TITLE : Sego L improvements

MODEL : All Sego L models

NUMBER : SI 240408

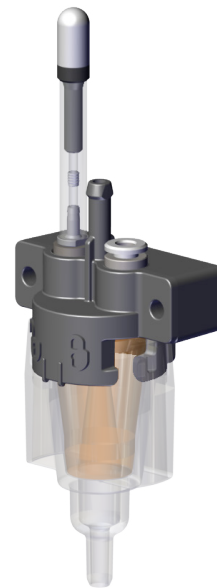
- improves the stability of fresh milk dosing with a more stable steam pressure
- an adjustable clean shot interval of 3 or 10 minutes has been added
- added a cleaning history log to check that the fresh milk section has been cleaned

The first machine with the new Air restriction and software has serial number **020002480553**

Old

New

- 6.000.331.091 Milk frother complete with new Air restriction, will be the same number with new parts

- 6.000.331.094 Air restriction (old type)

► *The old and new air restrictions are not interchangeable.*

To replace the old air restriction, order the 6.000.331.091 'Milk frother complete' which contains the customised parts.
